MIL-F-70807 (AR)
AMENDMENT 1
17 October 1988

FUZE, PD: M745
(LESS BOOSTER AND LEAD)

This amendment forms a part of Military Specification MIL-F-70807 (AR), dated 11 March 1988, and is approved for use within the U.S. Army Armament, Munitions and Chemical Command and is available for use by all Departments and Agencies of the Department of Defense.

FIGURE 1

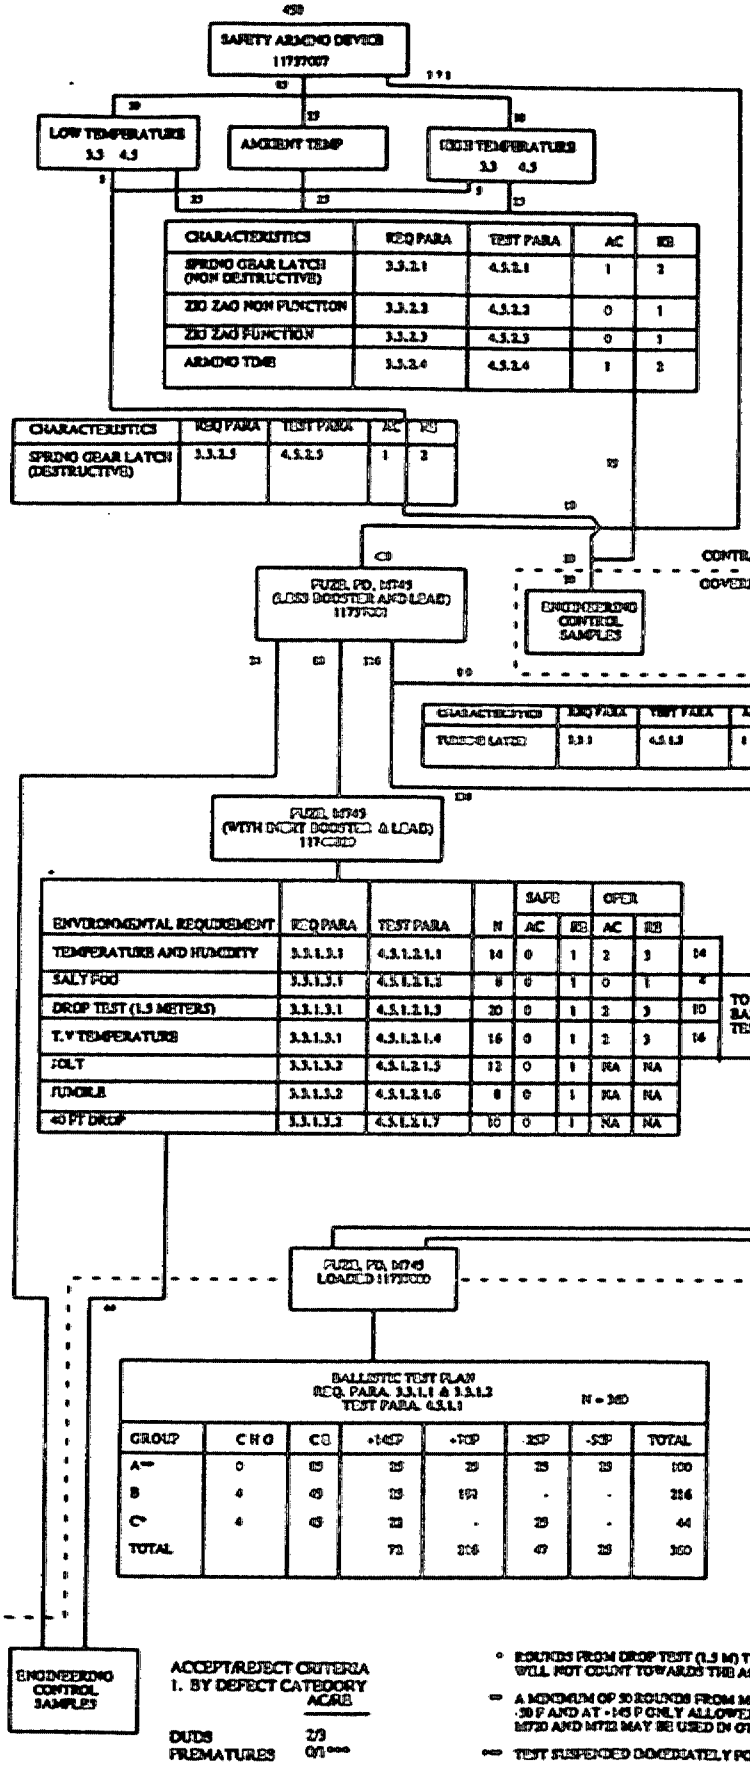
Delete in its entirety and substitute as per included sheet.

FIGURE 2

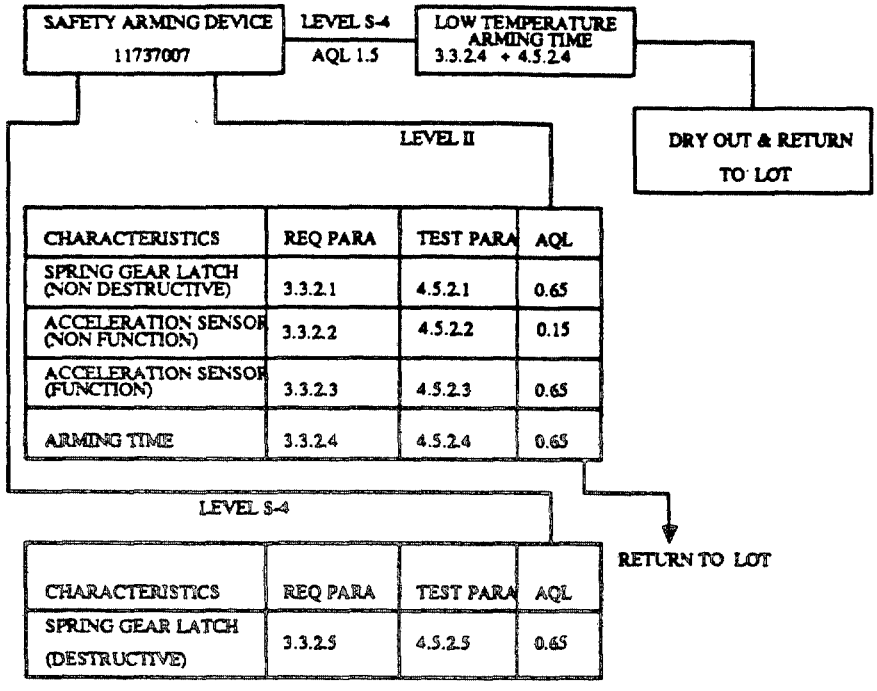
3.1.4.1 Initial production lot. Select at random ballistic lot acceptance samples from first production lot. Ballistic lot acceptance test plan is shown in figure 2.

Delete in its entirety and substitute as per included sheet.

FIGURE 3

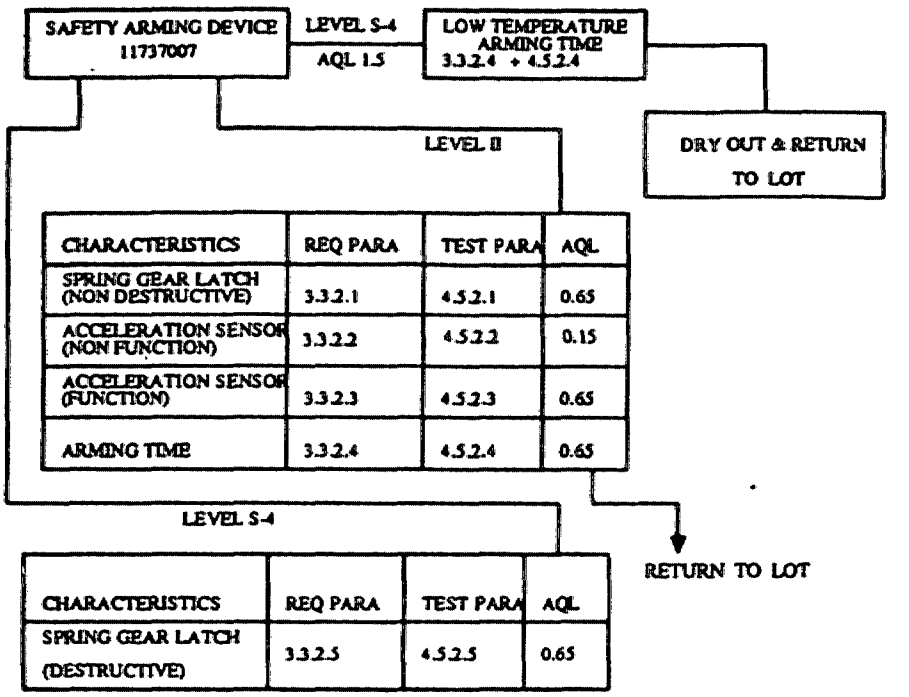
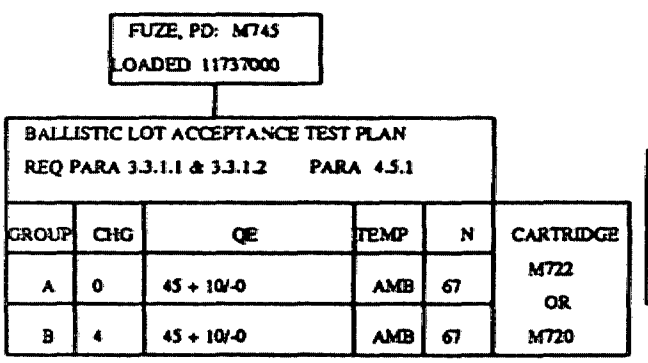
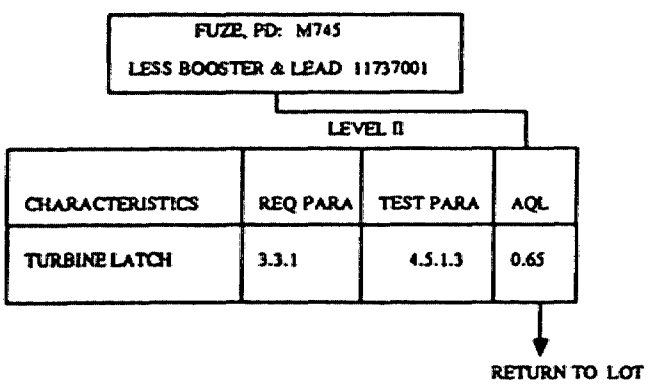
3.1.4.2 Production lot. Select at random ballistic lot acceptance samples from each production lot. Ballistic lot acceptance test plan is shown in figure 3."

Delete in its entirety and substitute as per included sheet.

FIGURE 4 INTERFACE CONTROL DRAWING

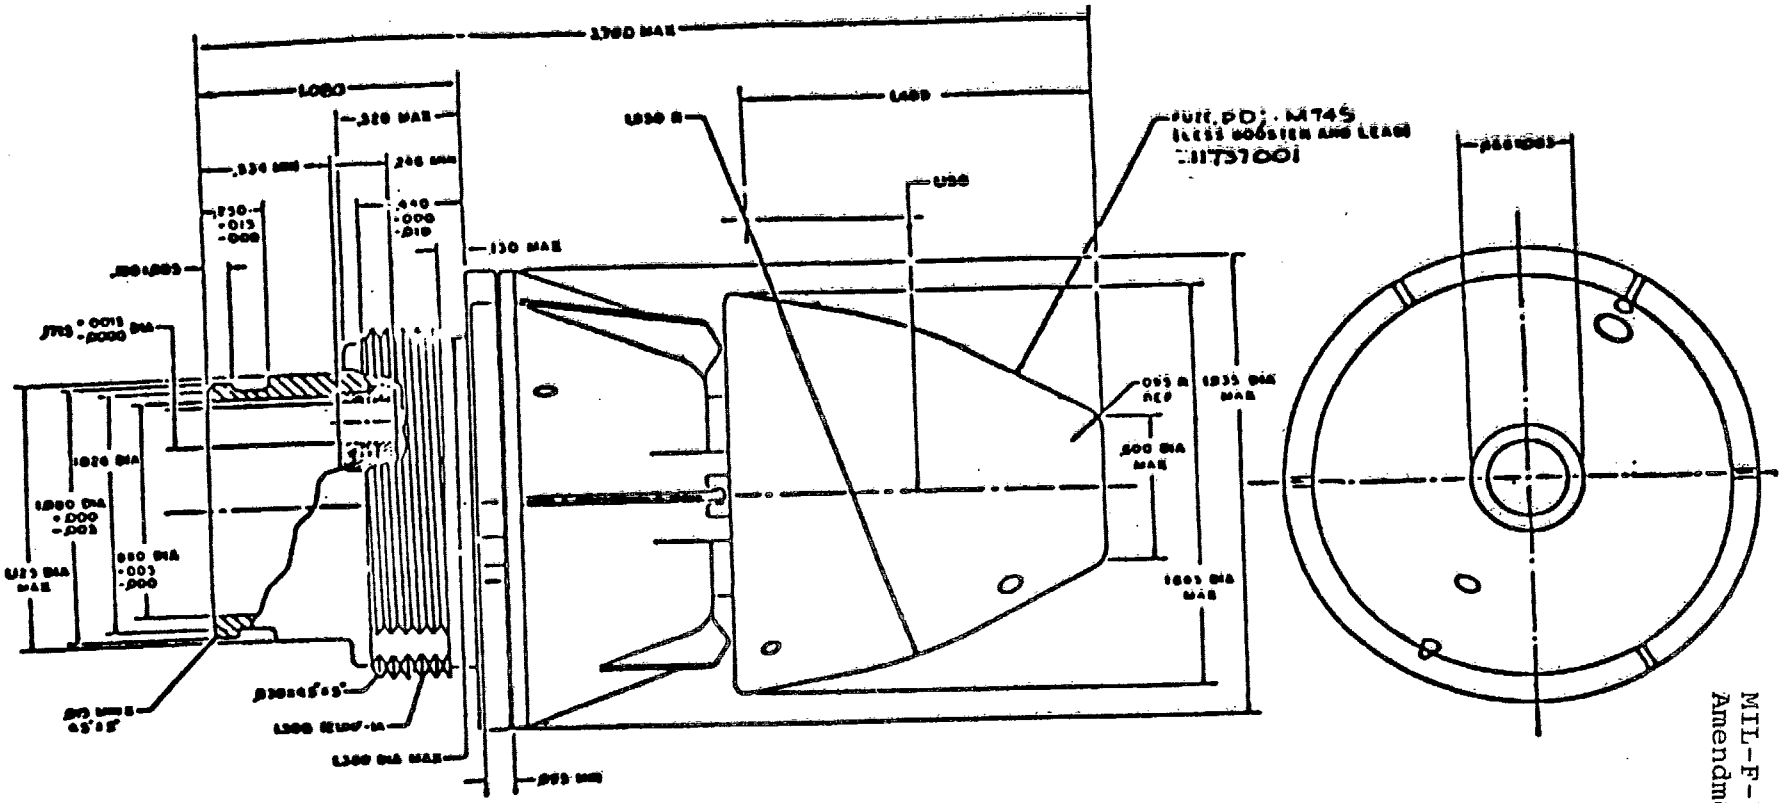
3.2: Change "(Figure 3)" to read "(Figure 4)."

Figure 4: Add new figure as per included sheet.
